U.S. NUCLEAR REGULATORY COMMISSION  
OFFICE OF INSPECTION AND ENFORCEMENT

Report No. 81-02

Licensee: SRI International

Facility Name: Hot Cell Facility

FIGURE II LOCATIONS OF SURFACE CONTAMINATION BY SURVEY

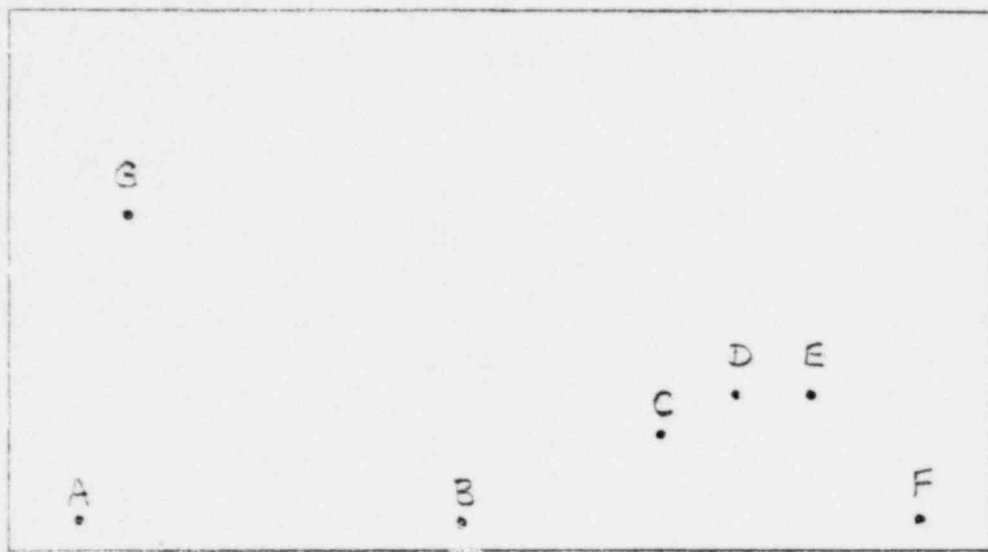
The entire wall from the floor to the ceiling and from the south wall to the door on the west wall was thoroughly surveyed with the GM pancake probes. Several locations were noted to be in excess of the release limits specified in Tables I and II.

A thorough survey was performed over nearly the entire East Wall of the Hot Cell Area using pancake GM detectors. The maximum direct reading was 15,000 cpm. This and a number of other locations on the wall were noted to exceed the release levels for contamination by reference to Tables I and II. A spot survey for removable contamination was made consisting of one wipe which indicated detectable activity, but which was below the release limits.

<u>Location Noted on Figures I &amp; II</u>	<u>Description of Location</u>	<u>Meter Reading with Background Subtract</u>
A	On East Wall, 2' from North door, 0.8' above floor	250 cpm (1,250 dpm per 100 cm <sup>2</sup> )
B	On East Wall, 12' from North door, 0.8' above floor	300 cpm (1,500 dpm per 100 cm <sup>2</sup> )
C	On East Wall, 8.8' from South wall, 3.1' above floor	1,550 cpm (7,750 dpm per 100 cm <sup>2</sup> )
D	On East Wall, 6.8' from South wall, 4.1' above floor	2,050 cpm (10,250 dpm per 100 cm <sup>2</sup> )
E	On East Wall, 4.7' from South wall, 4.1' above floor	10,000 cpm (50,000 dpm per 100 cm <sup>2</sup> )
F	On East Wall, 2' from South wall, 0.8' above floor	1,050 cpm (5,250 dpm per 100 cm <sup>2</sup> )
G	On East Wall, 3' from North door, 8.7' above floor	15,000 cpm (75,000 dpm per 100 cm <sup>2</sup> )
H	On West Wall, 5.8' from door, 0.8' above floor	850 cpm (4,250 dpm per 100 cm <sup>2</sup> )

I	On West Wall (concrete under baseboard), 9.5' from door, 0.8' above floor	550 cpm (2,750 dpm per 100 cm <sup>2</sup> )
J	On West Wall (concrete under baseboard), 2.8' from door, 0.8' above floor	750 cpm (3,750 dpm per 100 cm <sup>2</sup> )
K	On West Wall, 1' from South Wall, 4' above floor	350 cpm (1,750 dpm per 100 cm <sup>2</sup> )
L	On West Wall, 2.7' from South Wall, 6.7' above floor	1,050 cpm (5,250 dpm per 100 cm <sup>2</sup> )
M	On West Wall, 3.6' from South Wall, 1.5' below ceiling	450 cpm (2,250 dpm per 100 cm <sup>2</sup> )
N	On West Wall, 5.3' from South Wall, 1.5' below ceiling	150 cpm (750 dpm per 100 cm <sup>2</sup> )

The licensee representative was informed during the exit meeting on June 9, 1981, that the Hot Cell Area was still contaminated to unacceptable levels and that additional effort would be required by the licensee to effect decontamination. A final survey and written report should be completed by the licensee and submitted to NRC Region V for evaluation. The licensee representative did not state when the decontamination effort would continue or when a report would be forthcoming.
